**Amendments to the Drawings:**

## REMARKS

### I. The Drawings Have Been Corrected

FIG.6

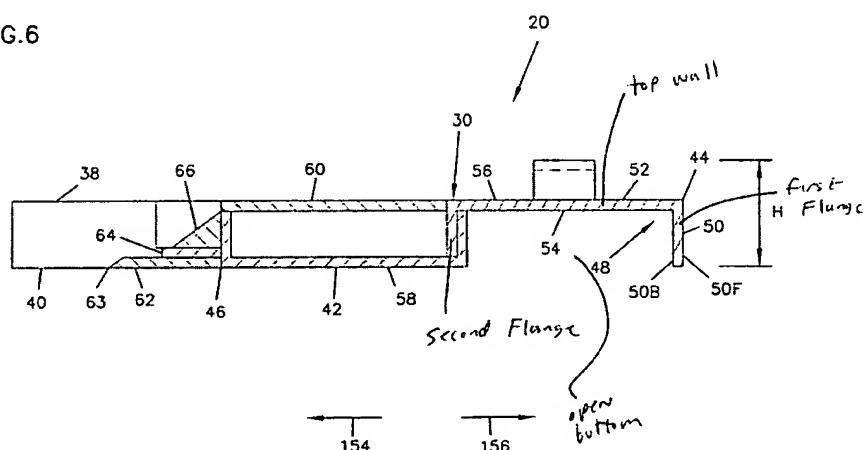
Figures 5 and 6 have been amended to change reference numerals 54 and 56 (corresponding to the direction arrows) to reference numerals 154 and 156. Reference numerals 56 and 60 have also been added to Figure 5 for clarity purposes. The attached Figures 5 and 6 replace all prior versions of Figures 5 and 6.

In the Office Action of April 3, 2006, the Examiner noted that reference characters 54 and 56 have each been used duplicatively. In response, the numbers 54 and 56 corresponding to the direction arrows in Figures 5 and 6 have been changed to reference numbers 154 and 156. Reference numerals 56 and 60 have also been added to Figure 5 for clarity purposes. Approval of the amendments to Figures 5 and 6 is requested.
